## Airworthiness Directive

Amendment 39-4658; AD 82-20-01

Airworthiness Directives; BENDIX: Applies to Bendix Engine Products Division Magnetos  
**PDF Copy (If Available):**

**82-20-01 BENDIX:** Amendment 39-4658. Applies to Bendix Engine Products Division magnetos with type designations listed below:

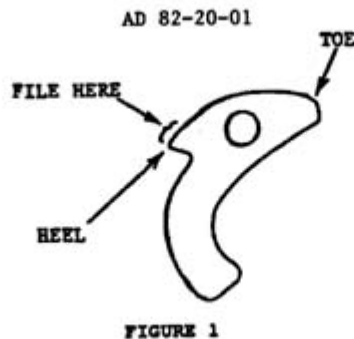
3. Use finger pressure to push inward on the toe (see Figure 1) of each flyweight so that the flyweight heel protrudes outward.
4. Using a fine #1, double cut, 1/2-inch wide file at least 3/32-inch thick, pass the file across the heel of the flyweight attempting to remove material (see Figure 1). If the flyweight has been properly heat treated, the file will "glide" smoothly over the heel of the flyweight, removing no material. If the flyweight is not properly heat treated (soft), the file will not "glide" easily across the surface of the flyweight heel, and material will be removed.

5. If an improperly heat treated (soft) flyweight is found, immediately remove and replace the cam assembly and/or the impulse coupling assembly with an assembly meeting the requirements of this AD, following procedures in the magneto overhaul instructions, and
